ELEVATOR TRIM TAB CONTROL WIRE ATTACHMENT

DRAWING REVISIONS JULY 1989

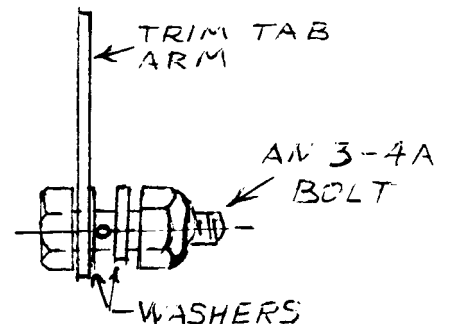
The .062 dia. hole drilled in the AN3-4A bolt for attaching the trim control wire is to be located .125" from the bolt head. The trim tab control arm is located between the bolt head and the wire. The control arm must be free to swivel without binding. A AN960-311 or 316L washer may be used to reduce excessive play of the arm. A AN960-316 washer and AN365-1032 nut are used to complete the installation. The nut is drawn tight to secure the control wire.
